# CITY OF ALBUQUERQUE

**Re: Shops @ the 24s  
32424 Louisiana Blvd NE  
Grading and Drainage Plan  
Engineer's Stamp dated: 7/23/2018 (H19D001)**

**SHOPS @ THE 24s**

**GRADING & DRAINAGE PLAN**

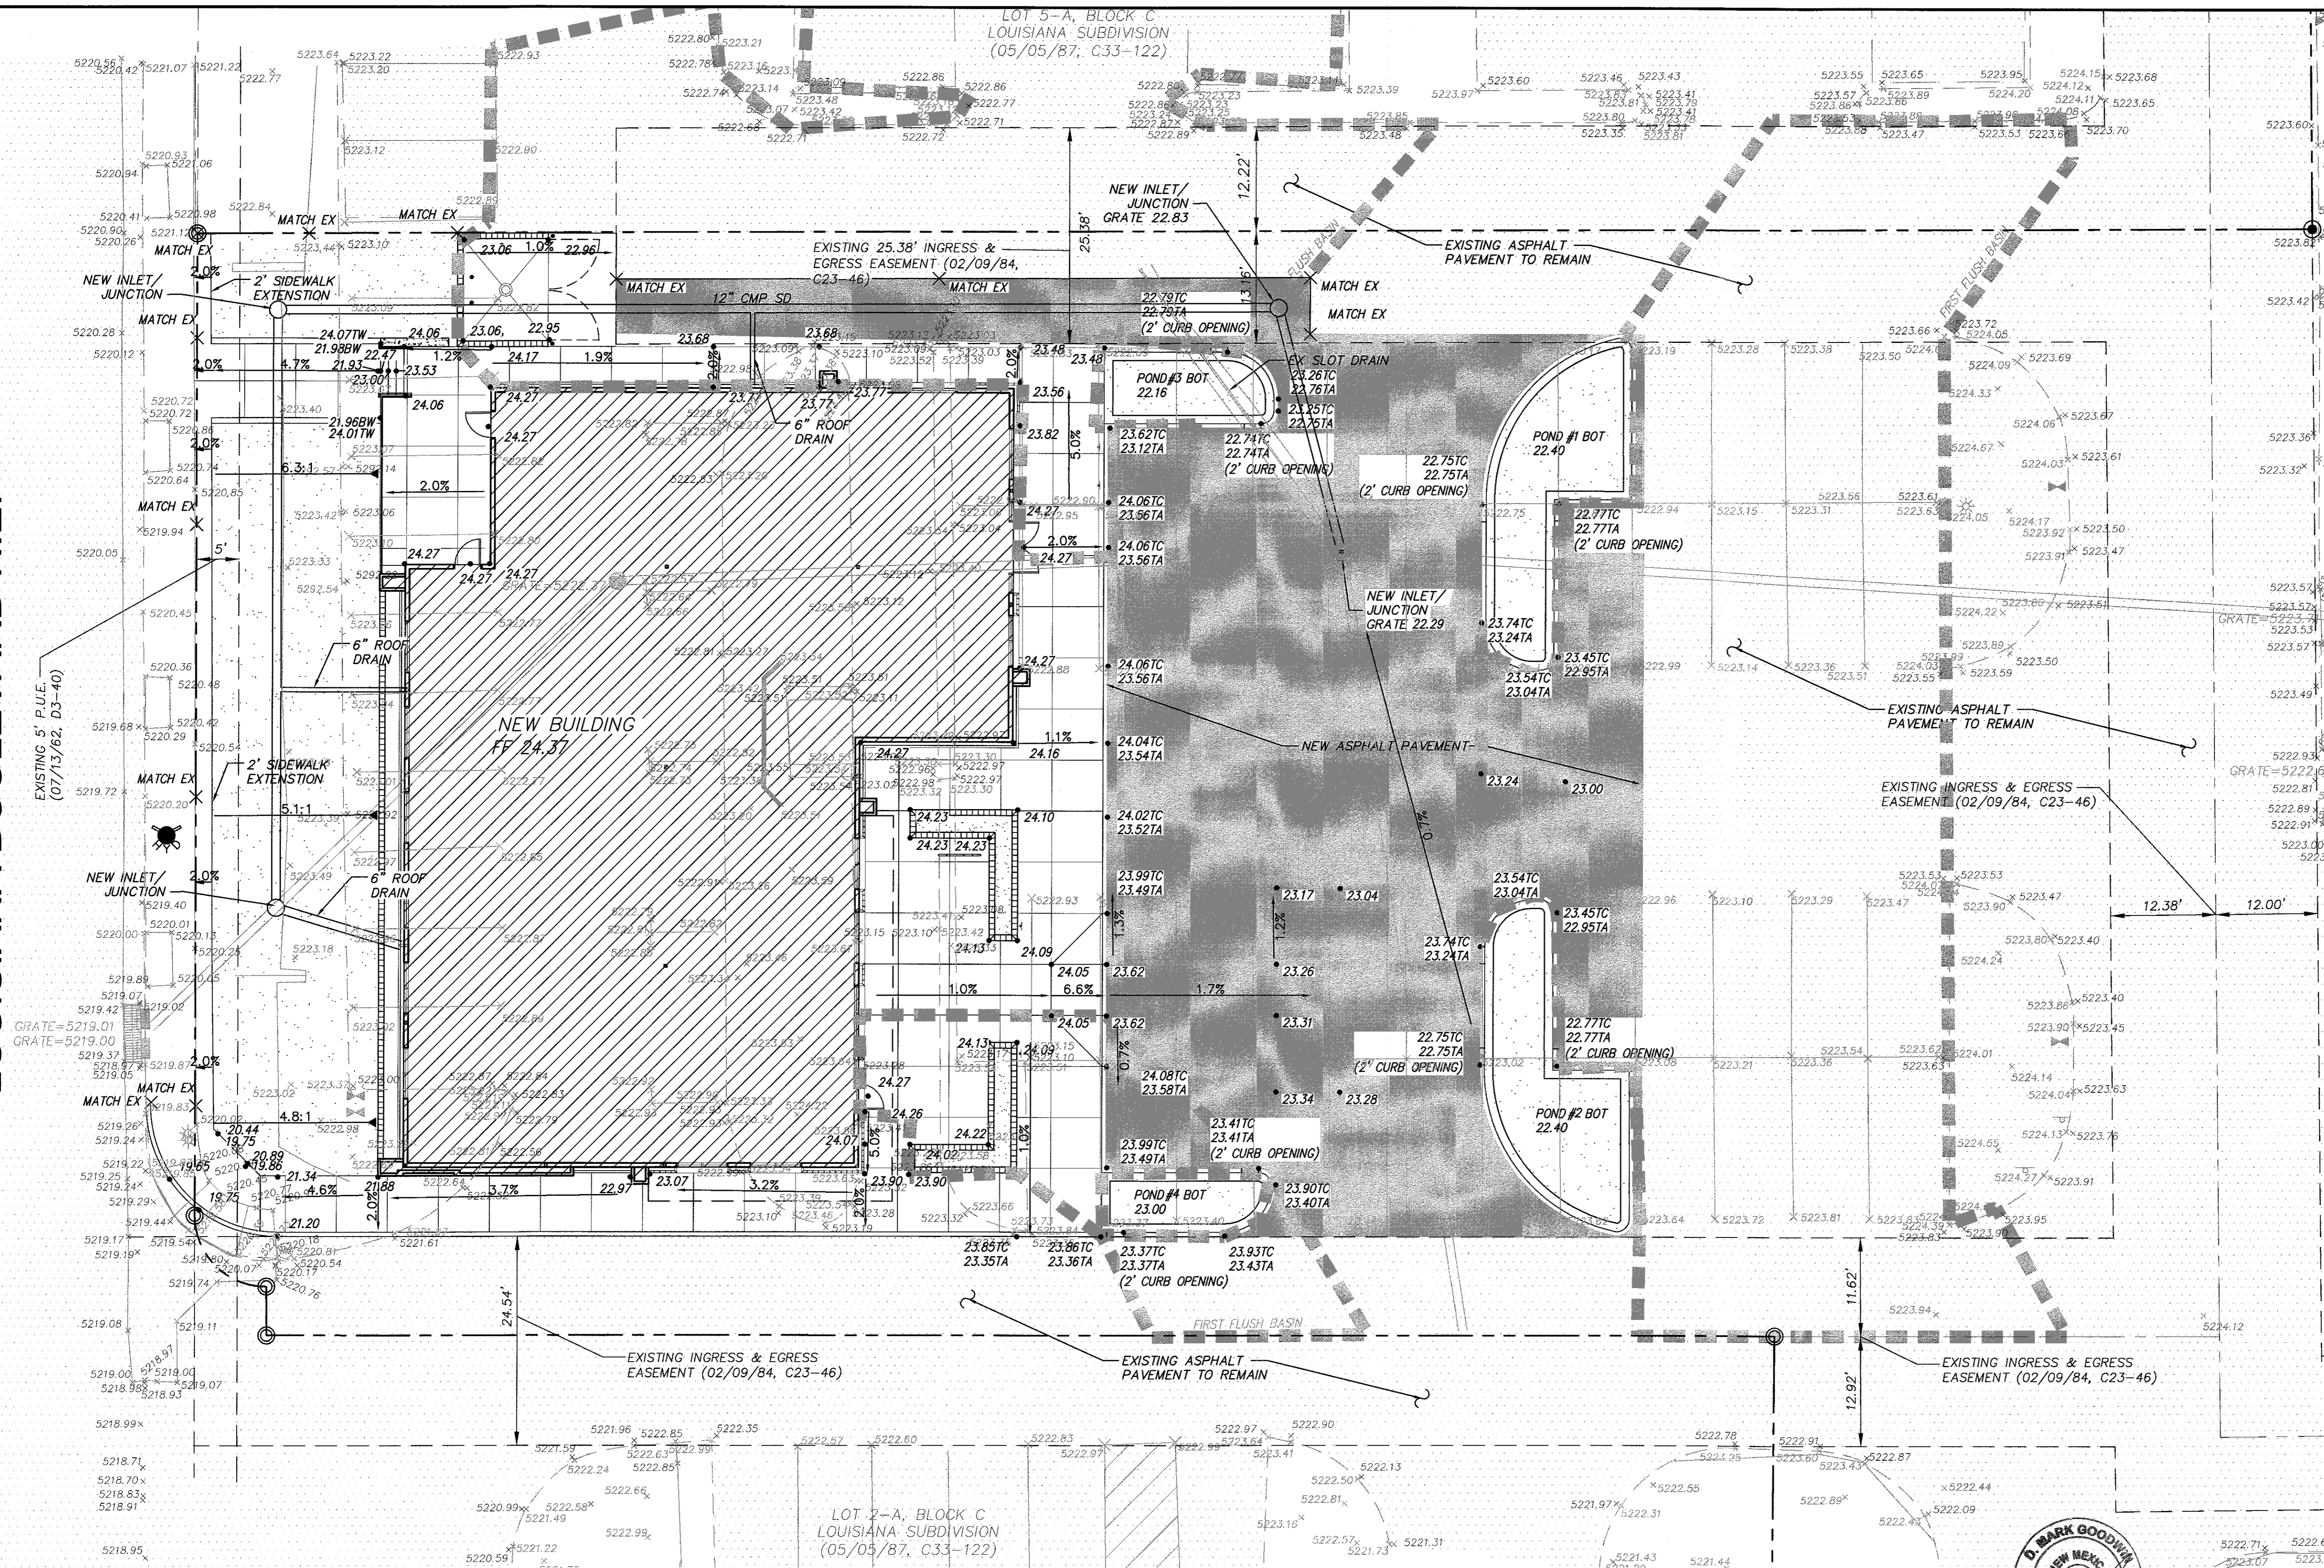
4. Drainage Covenants are required for the detention/retention ponds and private storm drains on this lot.
5. The grading plan is not legible. The proposed pavement hatching obscures existing topography, storm drains, and drainage basin boundaries.

6. Both detention and first flush retention are required. The capacity of the existing storm drain in Louisiana Blvd has been exceeded so the allowable 100-year discharge is 0.1 cfs/acre. The outlet structures on the existing parking lot ponds must be repaired and/or replaced as part of this permit. Include details and construction notes.

7. More detail is needed for all of the ponds including grading details, typical sections, volume calculations, and hydraulic structure details with calculations.
